UNITED STATES
DEPARTMENT OF THE INTERIOR
BUREAU OF LAND MANAGEMENTFORM APPROVED
OMB No. 1004-0135
Expires: January 31, 2004**SUNDRY NOTICES AND REPORTS ON WELLS**

Cone Federal #4

**Proposed Plugging Procedures
Cano Petro of New Mexico, Inc.
Cone Federal #4
30-041-20450**

**Cone Federal 4
30-041-20450
Tom R. Cone
May 7, 2024
Conditions of Approval**

Cano Petro of New Mexico, Inc.
Cone Federal #4
API 30-041-20450
WBD Before PA

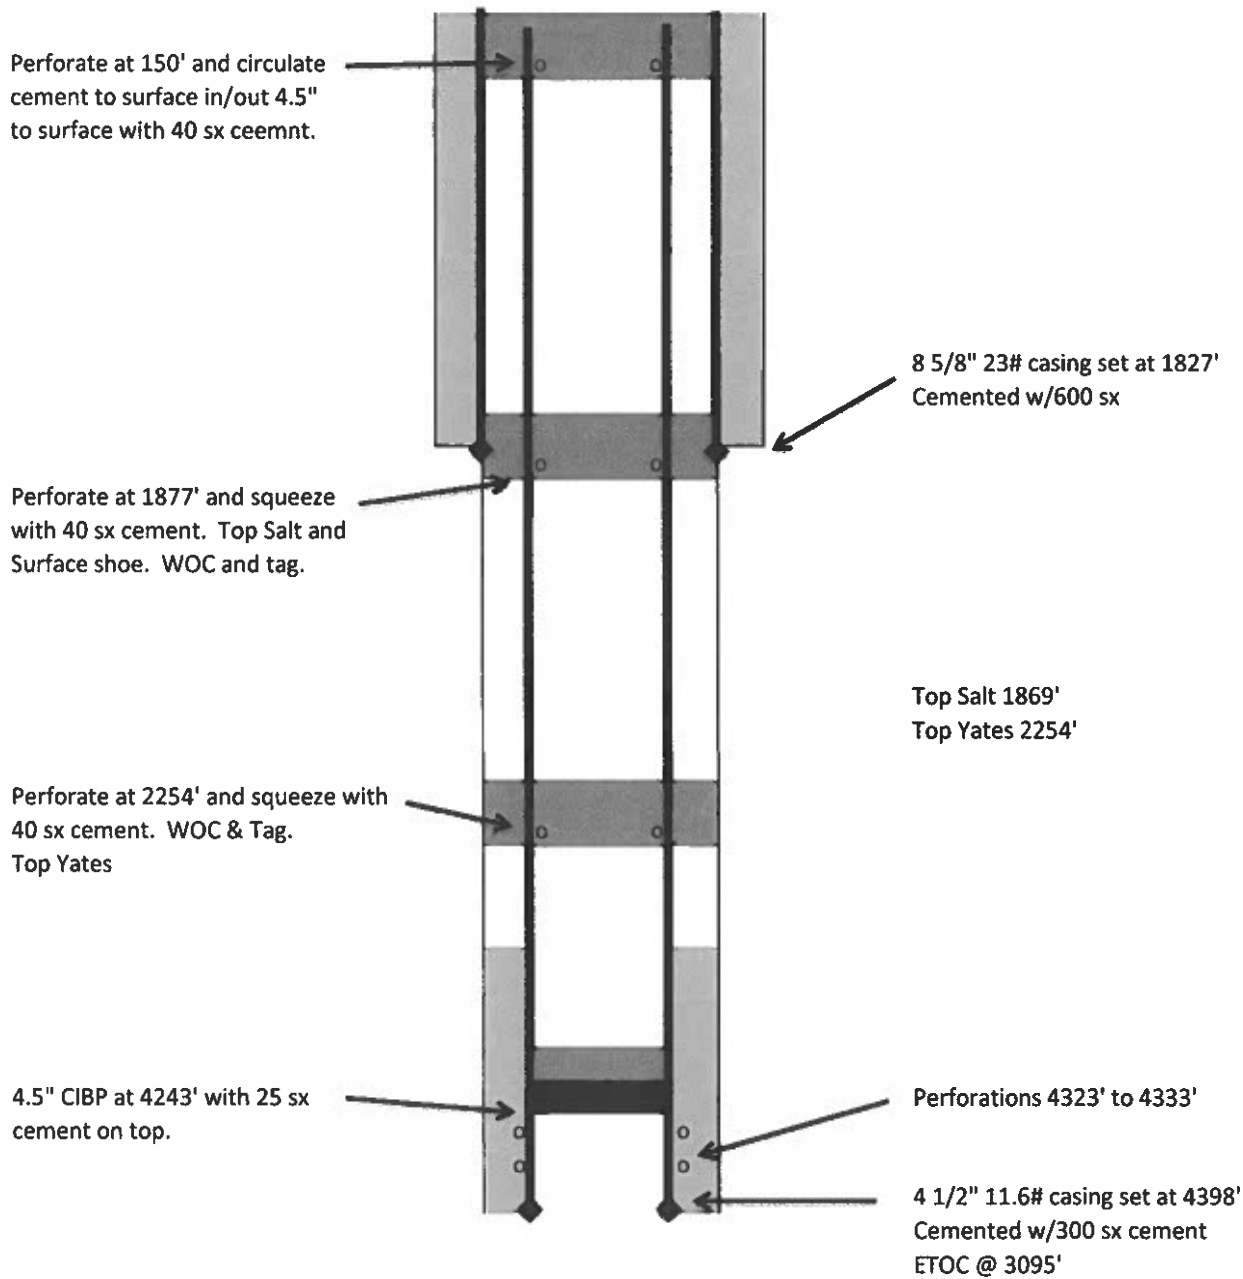
- 1. Operator shall place a CIBP at 4,243' (50'-100' above top perf) and place 25sx of Class C cement on top. WOC and TAG.**
- 2. Operator shall place a balanced Class C Cement plug from 3,120'-2,860' to seal the Queen and Grayburg Formations.**

- 3. Operator shall perf at 2,304' and squeeze cement class C cement to 2,182' to seal the Yates and bottom of Salt. WOC and TAG.**
- 4. Operator shall perf at 1,901' and squeeze cement class C cement to 1,776' to seal the top of Salt, Rustler and 8-5/8" casing shoe. WOC and TAG.**

- 5. Operator shall perf at 150' and squeeze cement class C cement to surface as proposed.**
- 6. Dry hole marker must be below ground.**
- 7. Surface reclamation will need to be completed once the well bore has been plugged. Please contact rflores@blm.gov for additional information.**
